Subject: Response to Submissions - Yiribana Logistics Estate (SSD-10272349)

Attachment 1: Environment and Heritage Group comments in relation to proposed stormwater management strategy for Yiribana Logistics Estate (SSD-10272349)

Attachment 2: Environment and Heritage Group comments in relation to potential alternative stormwater strategies for Yiribana Logistics Estate (SSD-10272349)

Stormwater Management Strategy (DesignFlow interpretation based on submitted information)

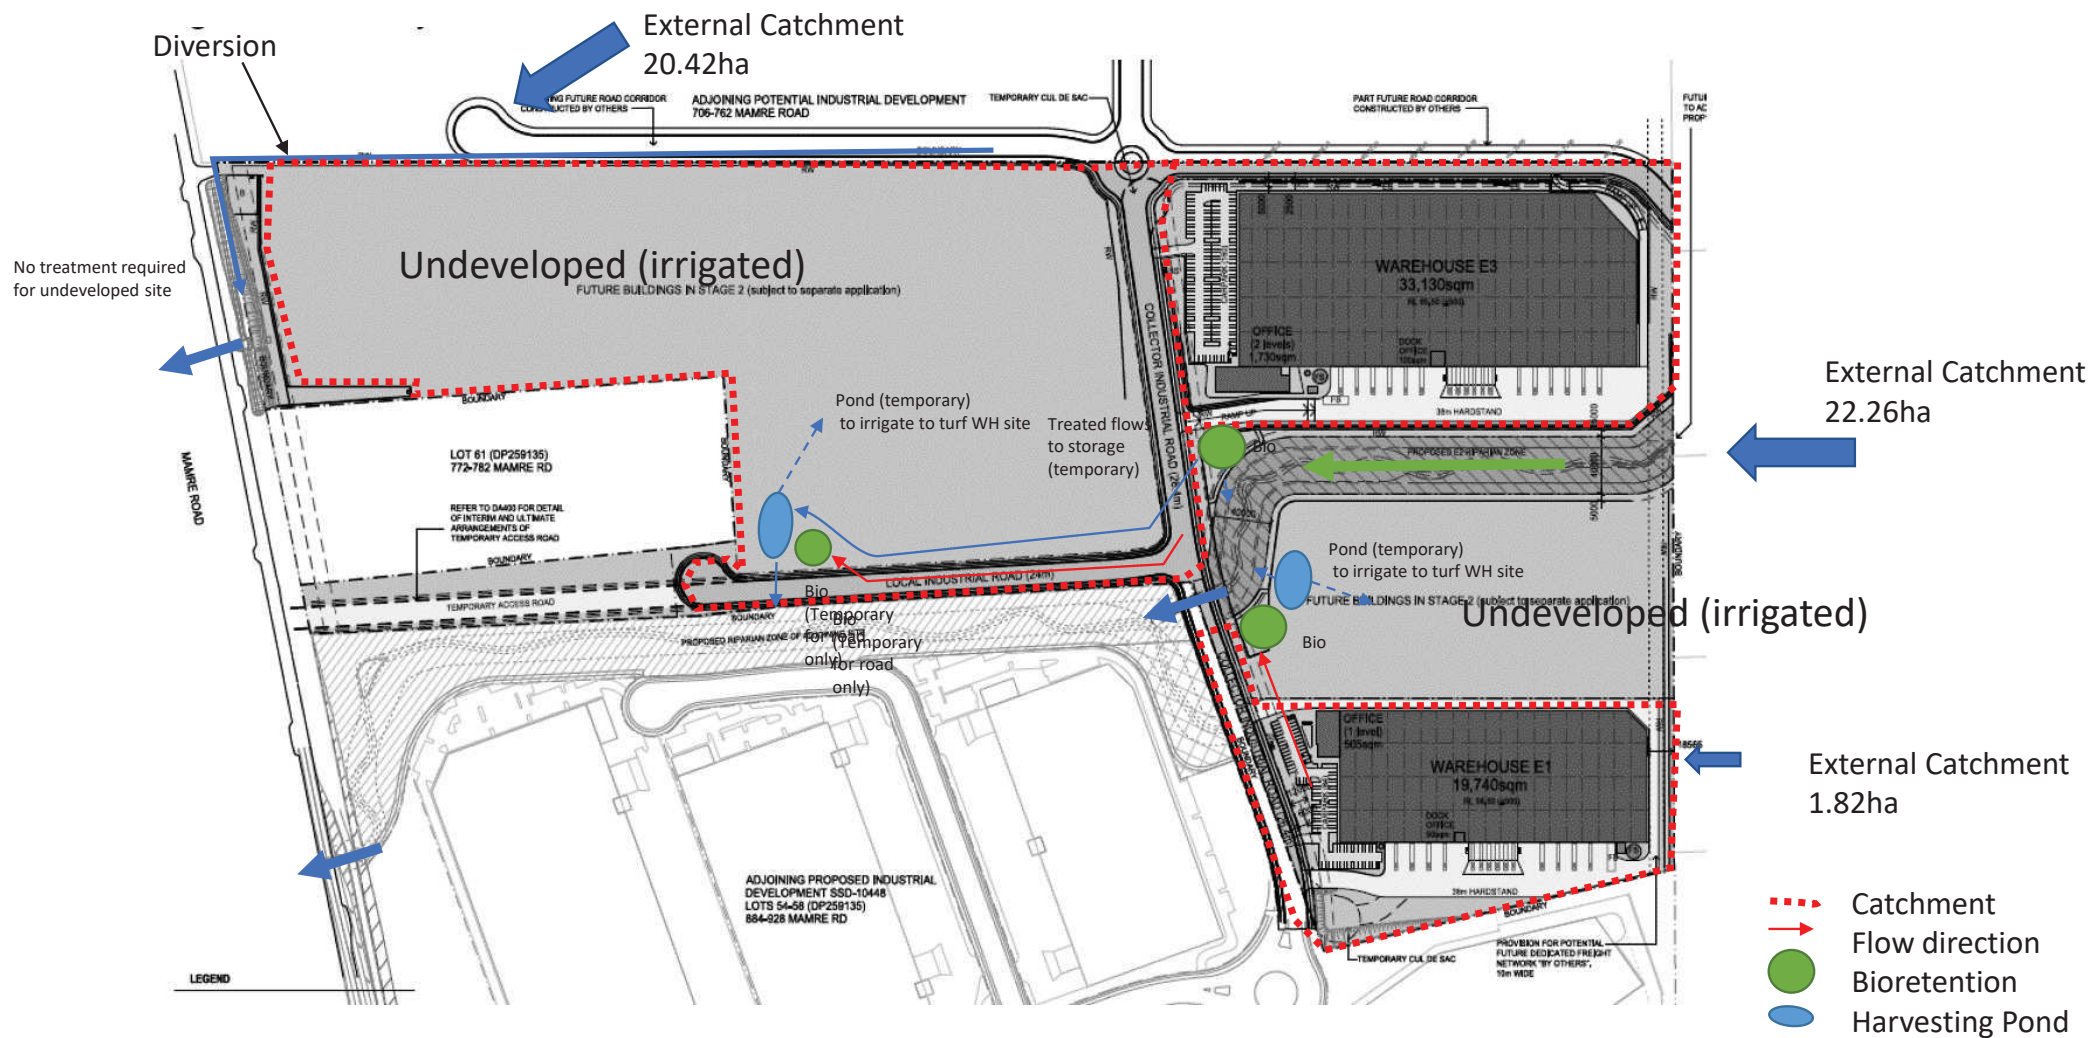
- The western 22.26ha external catchment enters the site into the proposed swale / waterway corridor and the online harvesting pond. Given the swale and pond are online to the external catchment, then this catchment needs to be included in the modelling. Currently the site is undeveloped but will ultimately be developed with WSUD. Both scenarios need be included in the strategy and modelling.

- The swale has been included in the MUSIC modelling to treat the development flows. However, development flows do not engage with the swale as they pass through the proposed bioretention systems and discharge to the proposed harvesting pond. The swale should be removed from the MUSIC model.

- To simplify the strategy and modelling, it is recommended that the harvesting pond is moved offline (refer potential alternative strategy at Attachment 2).

Potential Alternative 1 Stormwater Management Strategy (suggestion only)

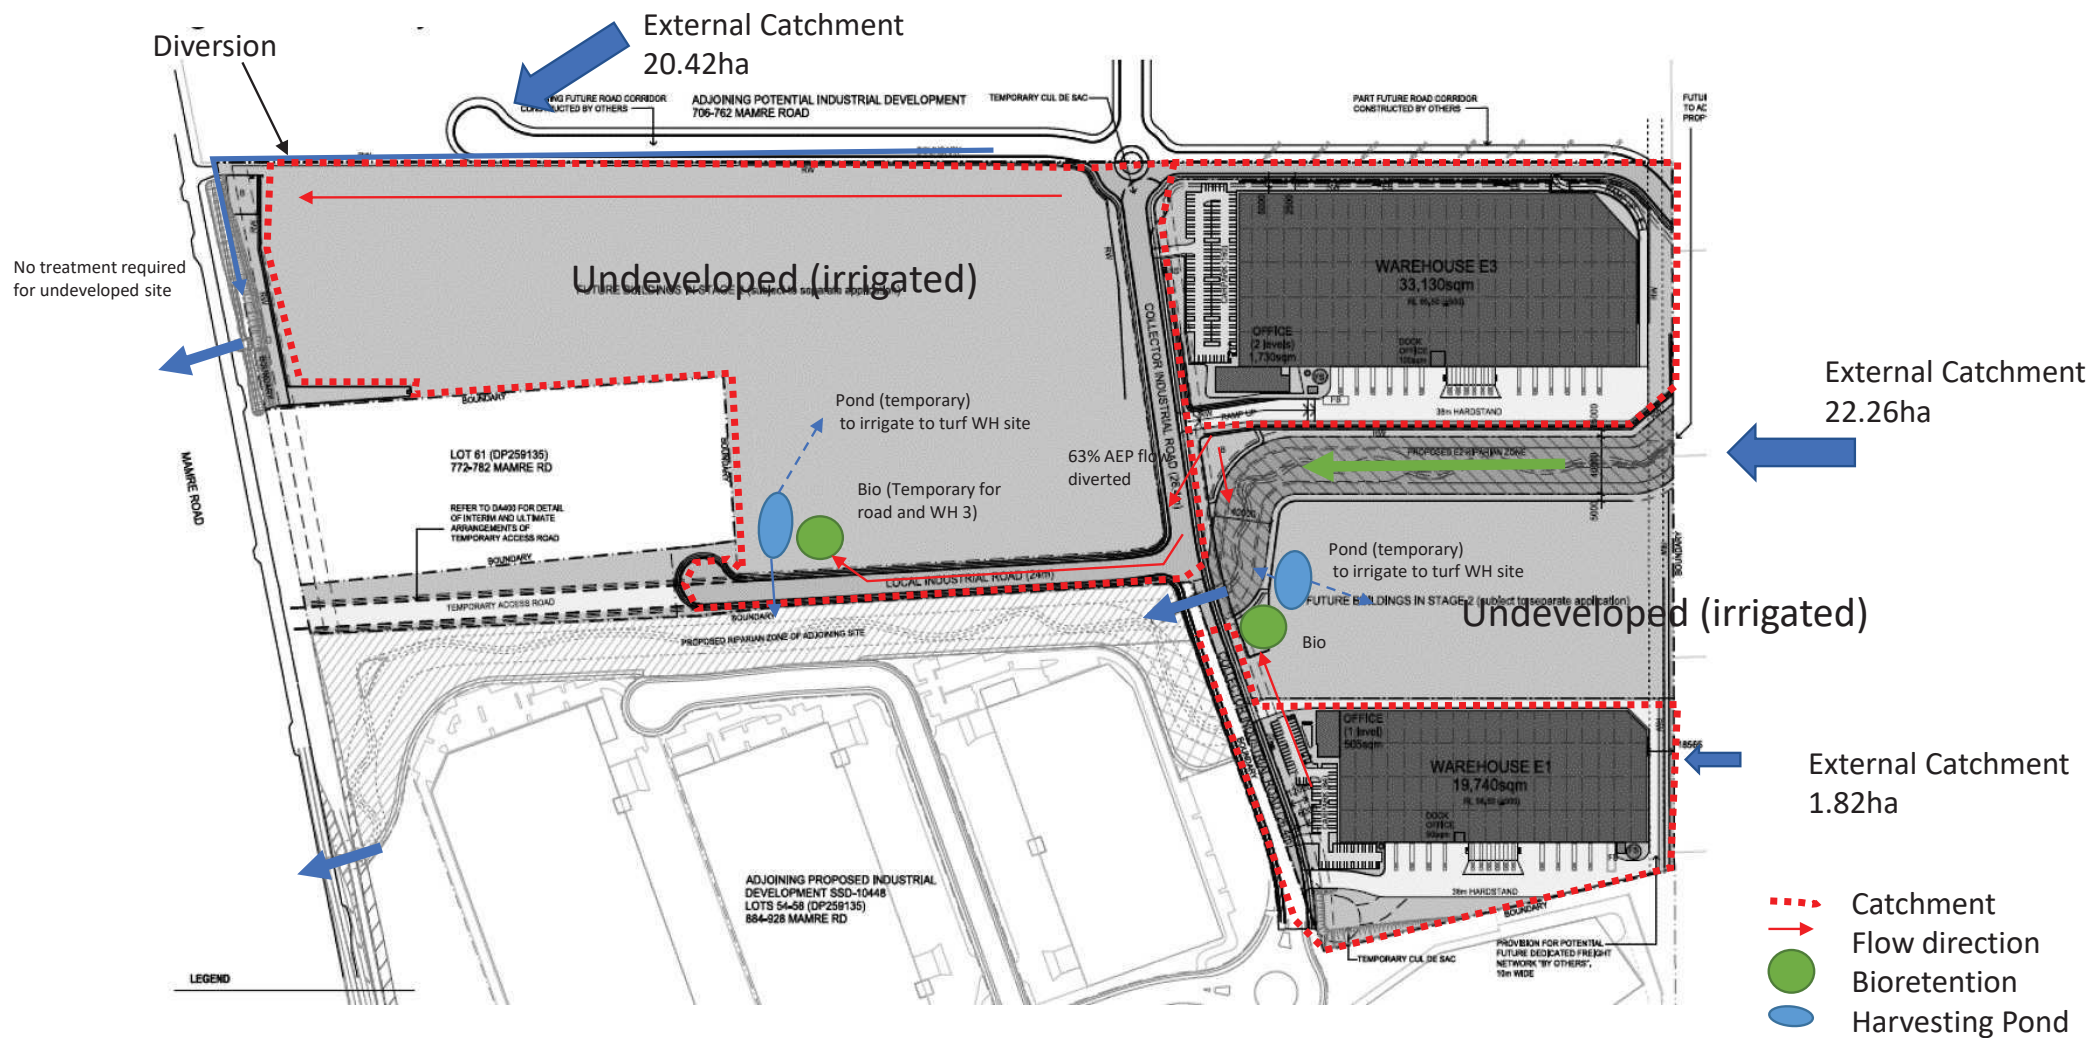
EHG notes that there may be alternative solutions for the implementation of a simple 'interim strategy' stormwater management strategy that does not require any change to the layout of roads, lots or warehouses. These potential alternative solutions are identified in **Attachment 2**. These solutions may also allow development of additional lots in the future.
